TOWN OF LYONS, COLORADO
RESOLUTION 2020-91

**A RESOLUTION OF THE TOWN OF LYONS COLORADO TO APPROVE THE SEVENTH
AMENDMENT TO THE CONSTRUCTION AGREEMENT WITH WALSH CONSTRUCTION INC.
FOR BOHN PARK PHASE II - PROJECT: PW20E-2**

Walsh Construction, Inc.
Change Order Proposals

PROJECT: Town of Lyons - Bohn Park (Phase 2)

WALSH CONSTRUCTION
BOHN PARK
TRAIL GATES

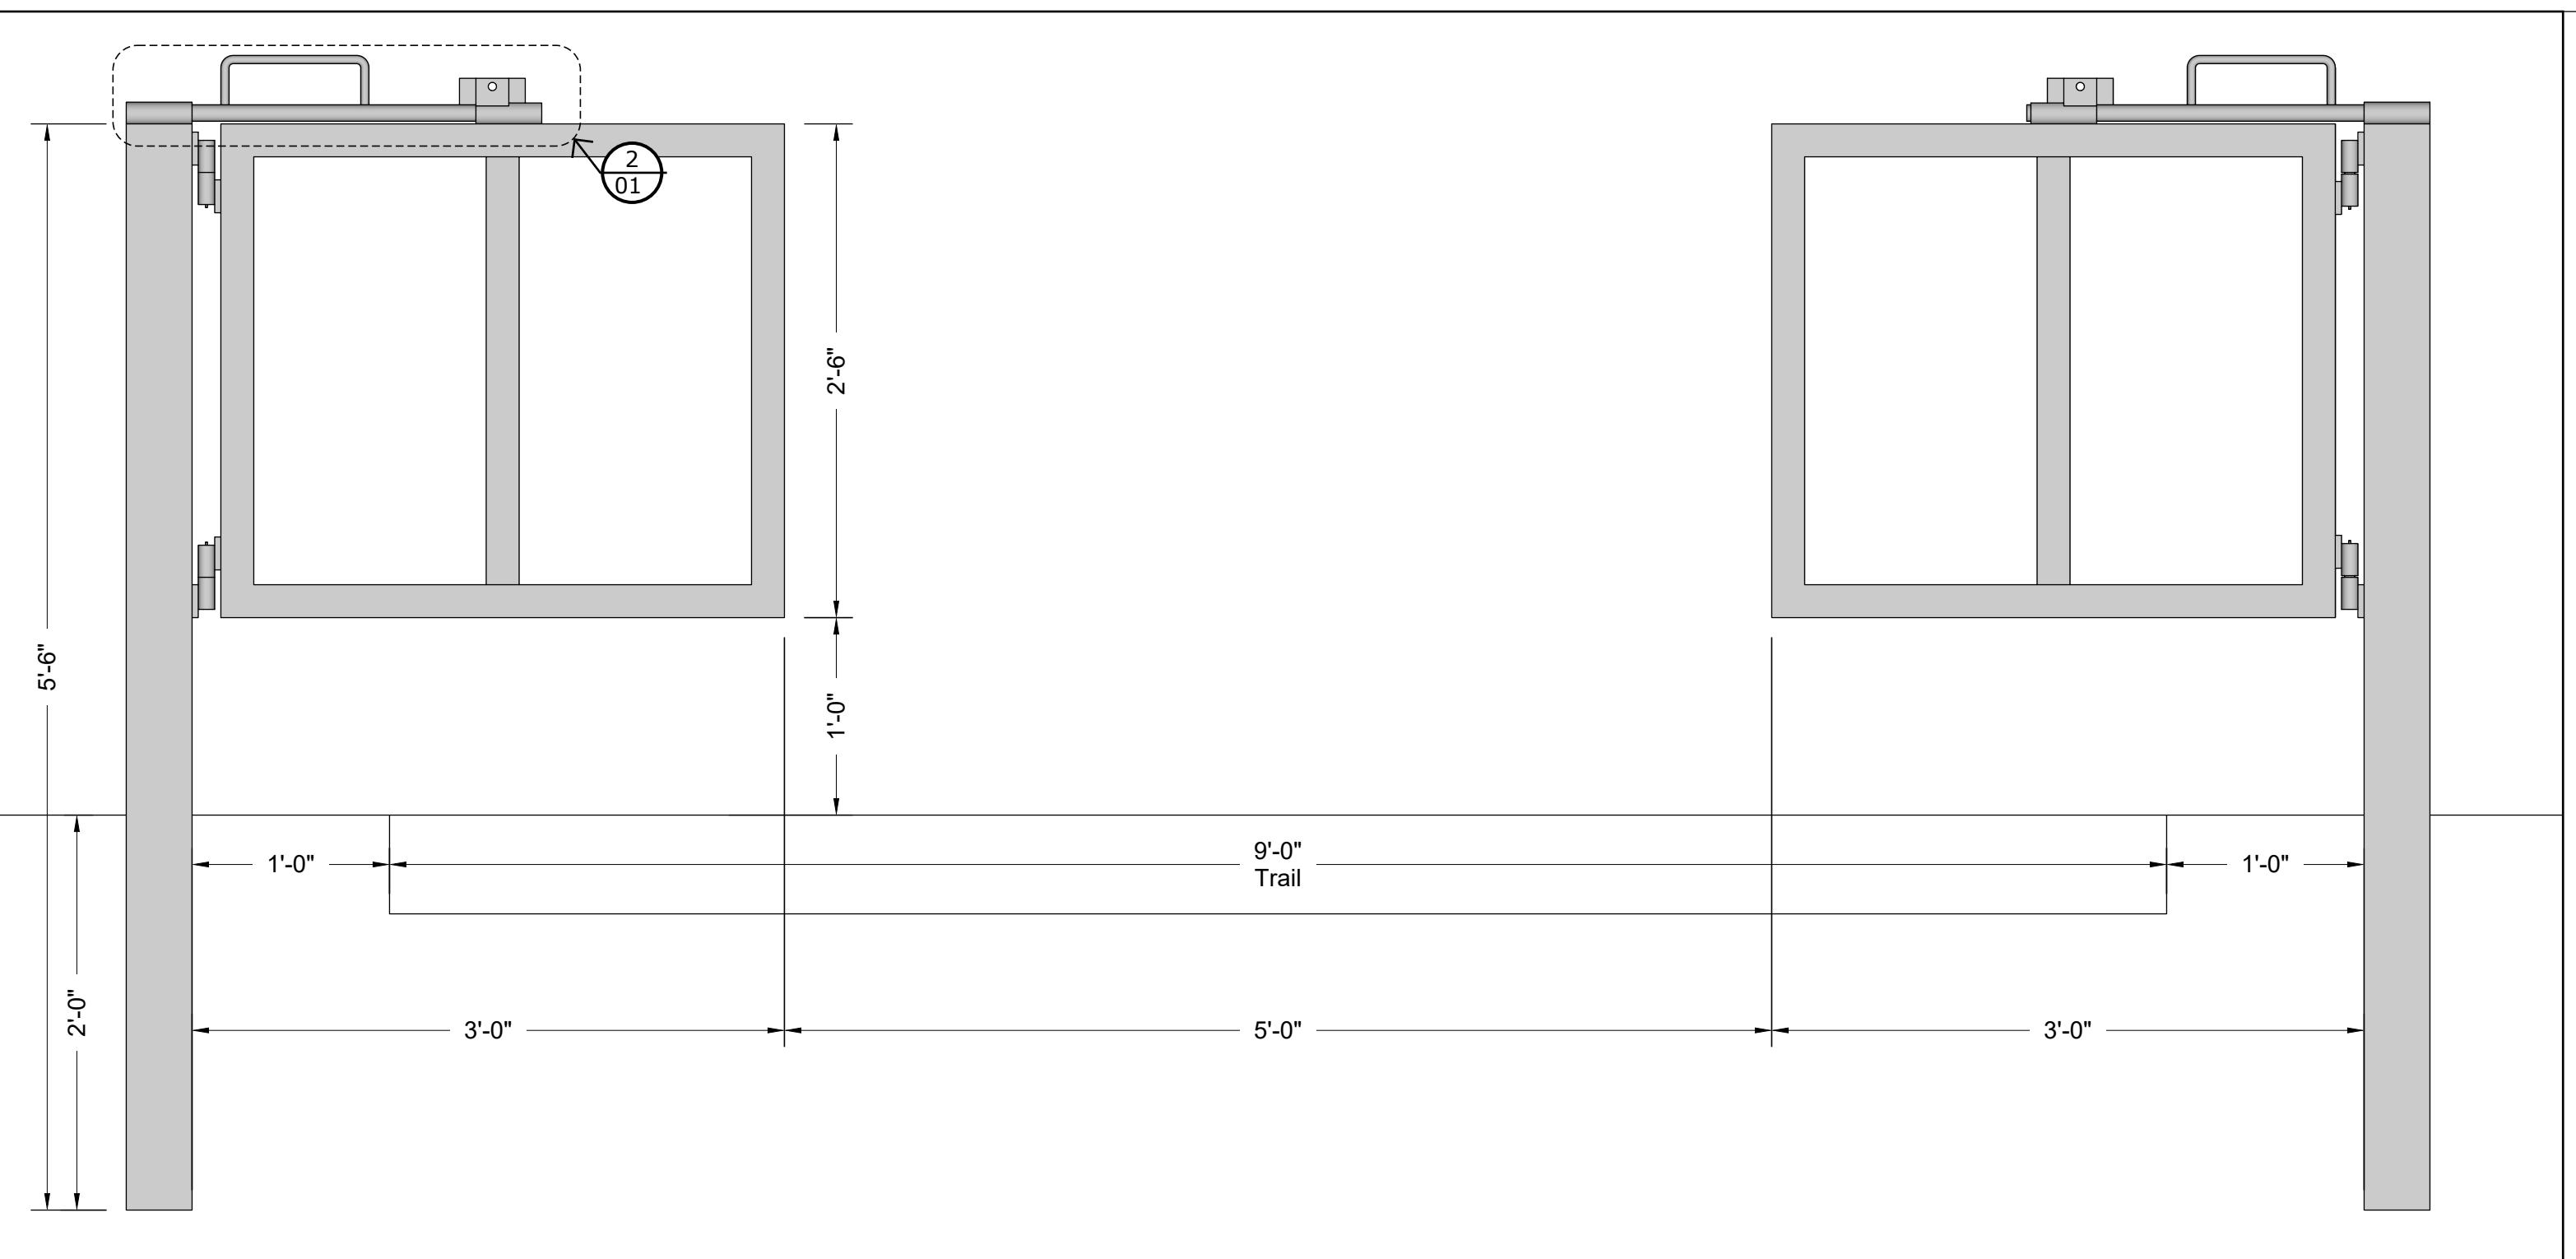
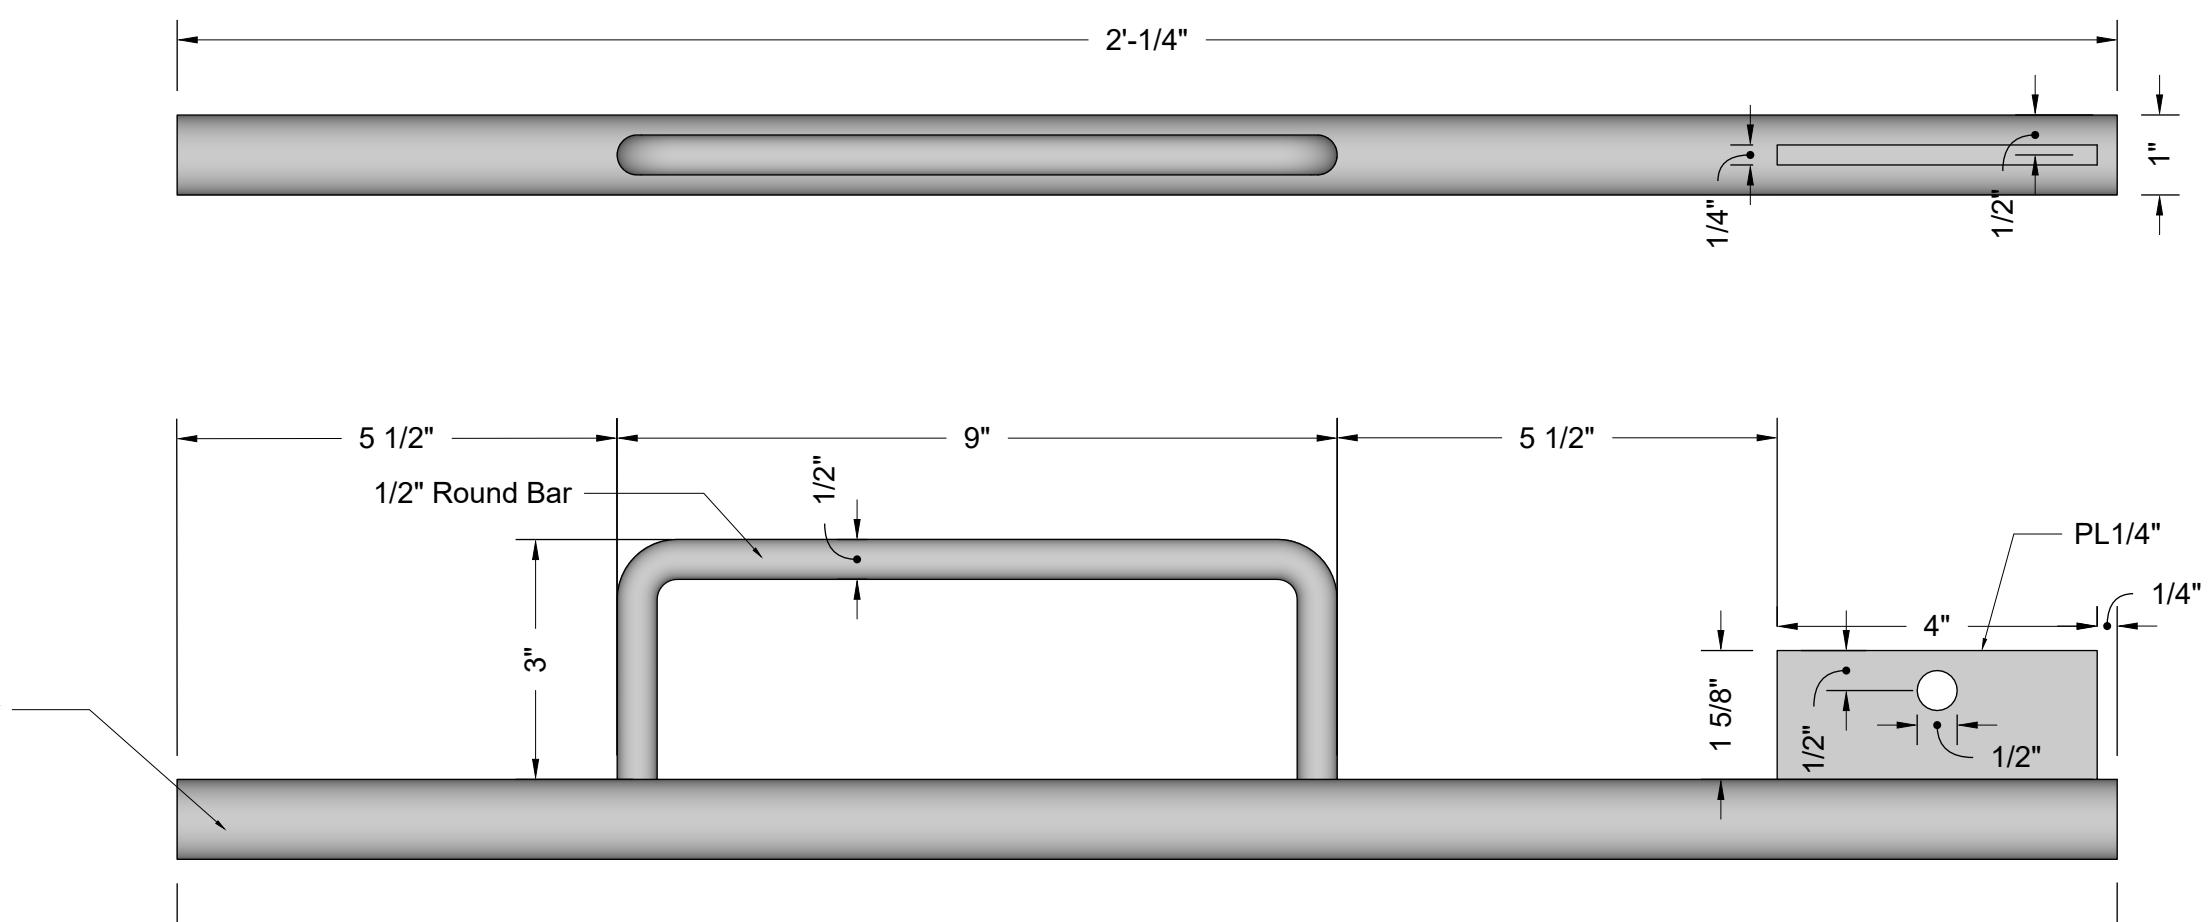
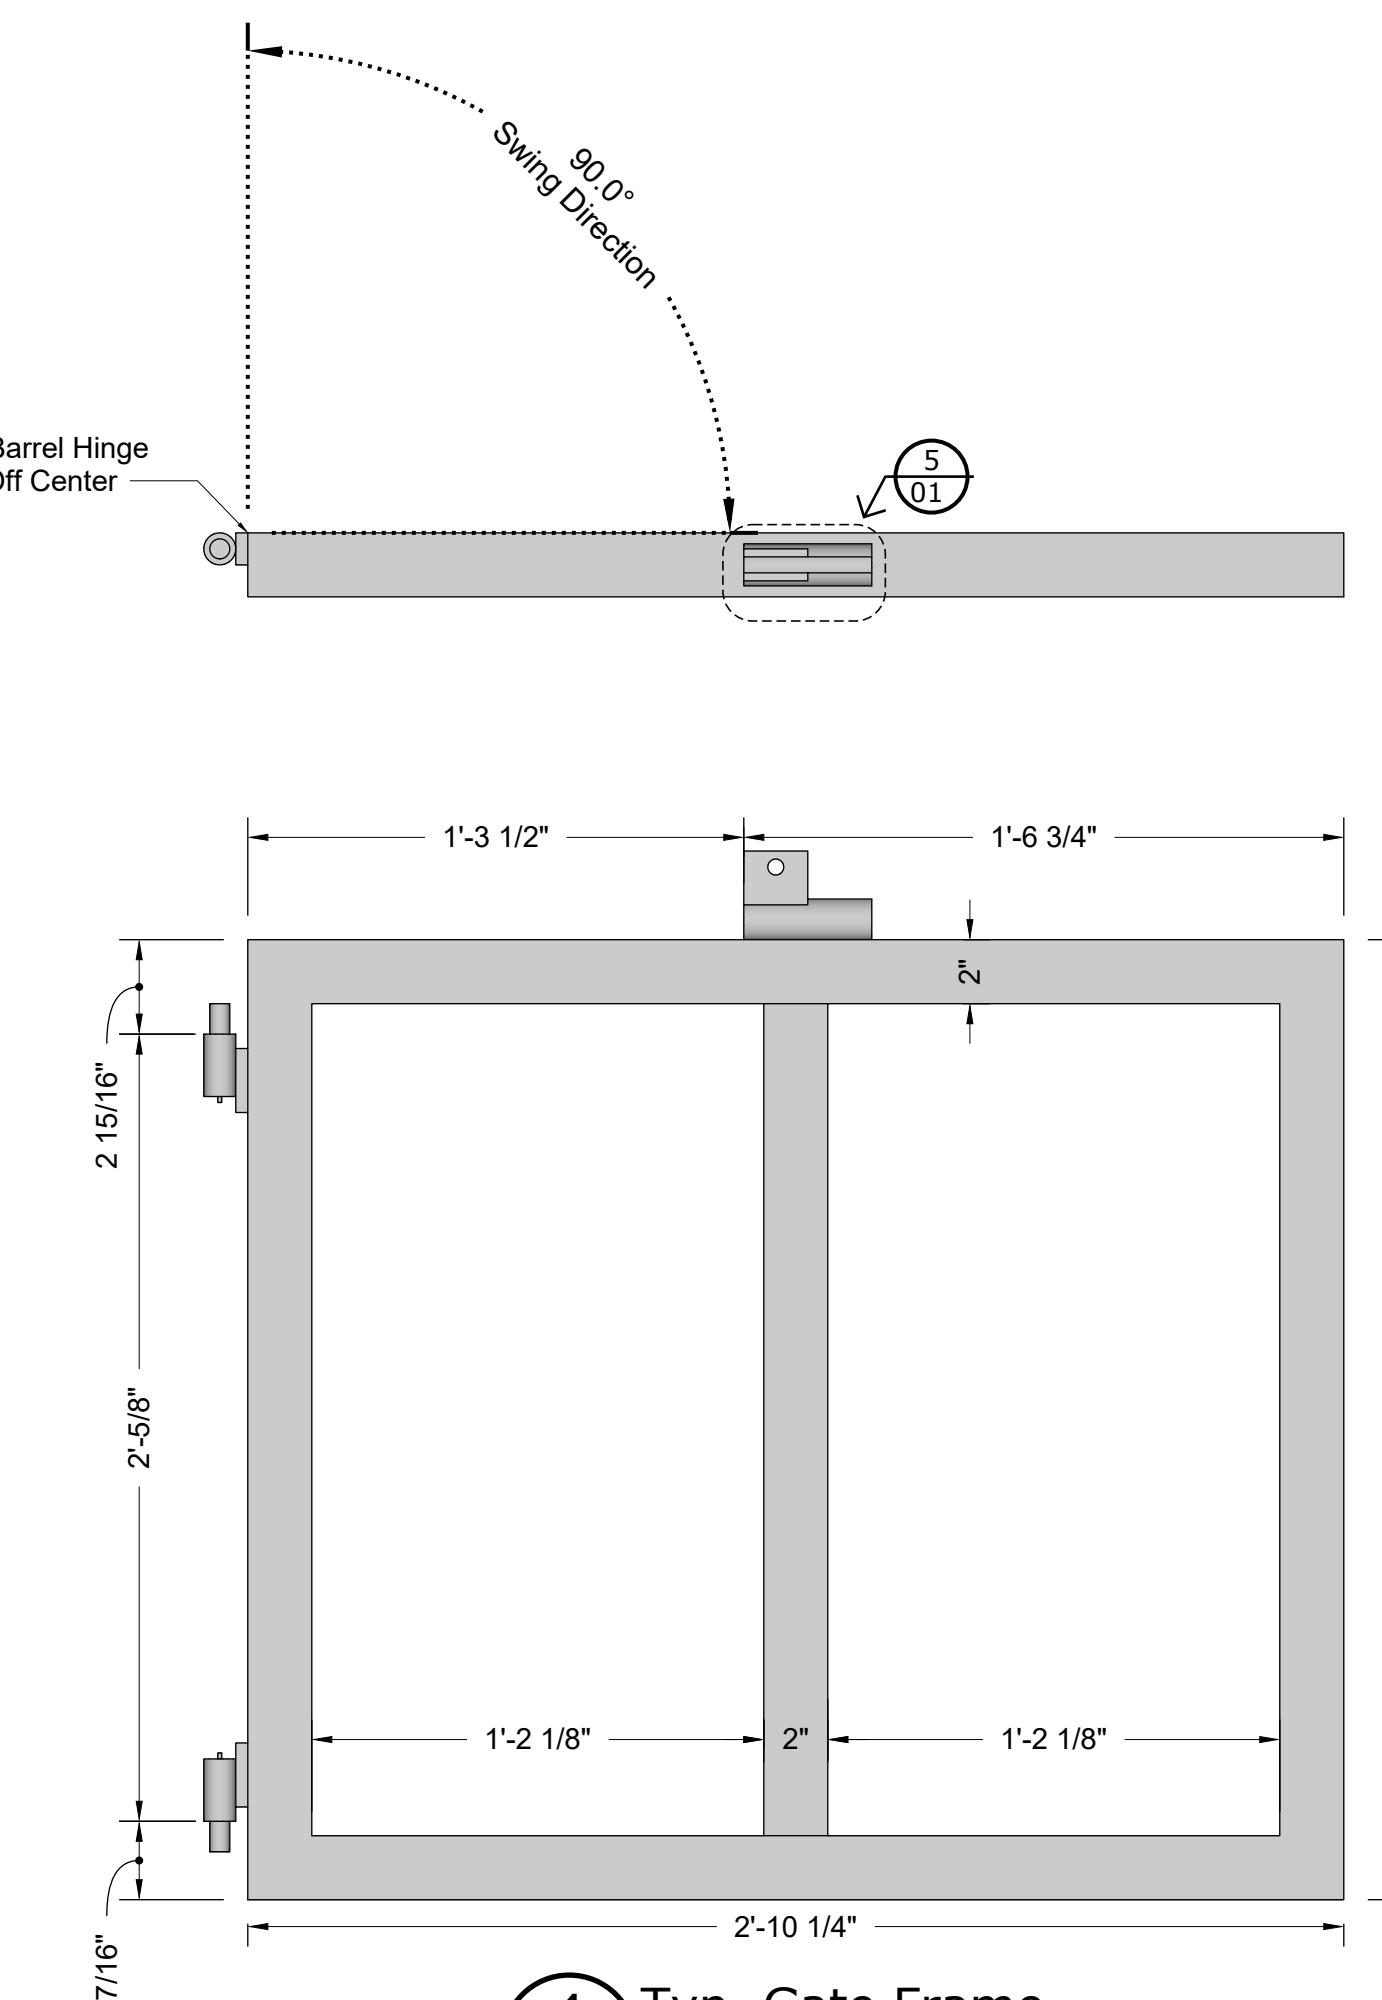
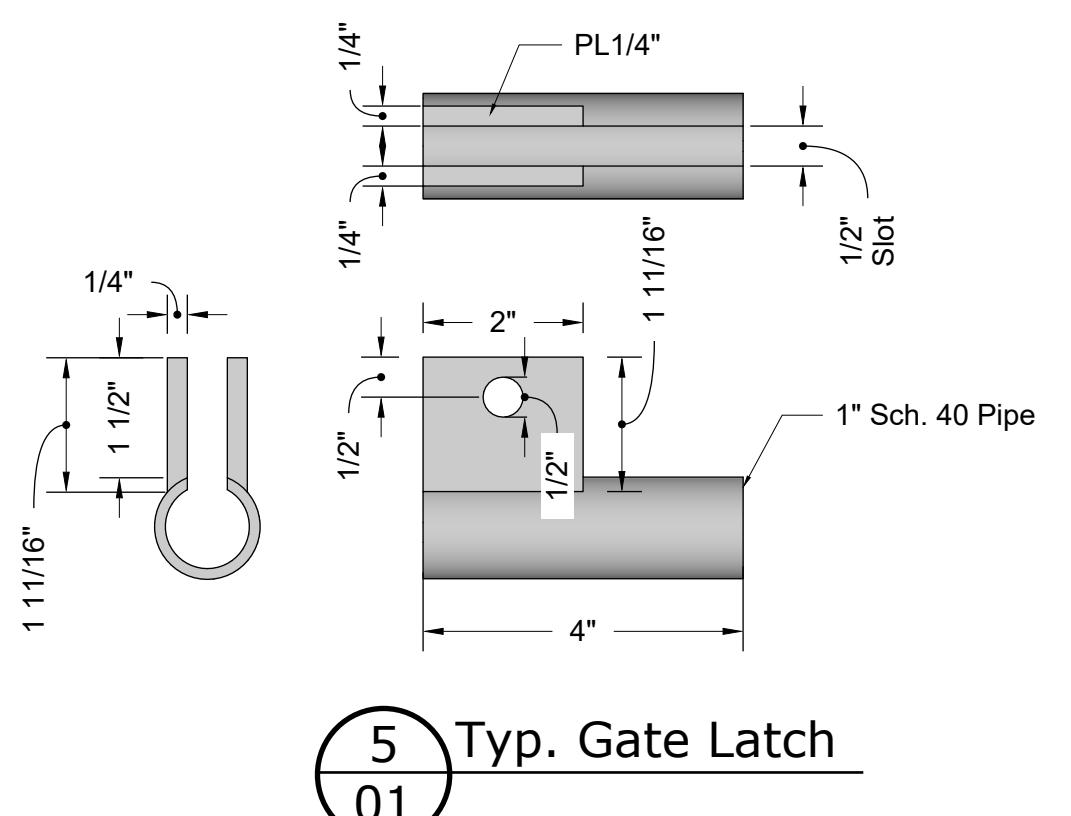
At the request of the Town, 2 sets of additional Trail Gates were added at the north entrance to Bohn Park in order to limit vehicular access to the park from the north entrance, while maintaining 2nd Street access for pedestrians using the adjacent sidewalk and crusher fines paved trail. To help offset cost for this revision, the Town received a cost credit for material that was deleted from the original plan design, which included a 10' length Heavy Duty Tube Gate and 4x4 posts that were not installed at either location. The cost for materials was found to be fair and reasonable when compared with average material cost data found on websites with similar dimensional and material properties. Labor rates met the minimum requirements of 2020 Davis Bacon standard wage rates for Boulder County, Colorado and industry standard rates for specialized drafting. This amount will be paid as a Contract Amendment. See attached documents and related plan sheets for breakdown of costs.

NOTES: Please find attached the following from Distinctive Welding - shop drawings for the Trail Gates per the revised detail on Sheet L2.5 from DHM Design. Please note that the reflective tape shown on DHM's drawings will be applied by Walsh Construction after installation. Thanks!

Finish: ~~Powder Coat Color TBD~~ Black
